# ETC® Release Note

## Eos®/ Ion™ Lighting Control Family Software

Version 1.4.1 software

500004064

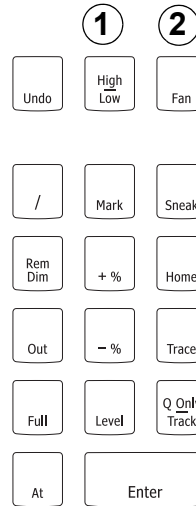
From Eos v1.3.1 to v1.4.x, two keys have been re-mapped and require that you change the physical keys on the console keyboard to match the software.

- Step 1: Use the key puller provided to remove the two keys shown below in the order indicated below.
- Step 2: Place the keys in their new correct locations and press them down firmly.
- "High/Low" replaces "Relate" and "Fan" replaces the blank key.

Below is the correct orientation to use the key puller for these keys.  
Remove "Relate" and the adjacent blank key.

Remove the keys in the order shown by the numbers next to each location.

This is the correct final position for the keys.  
"High/Low" replaces "Relate".  
"Fan" replaces blank.
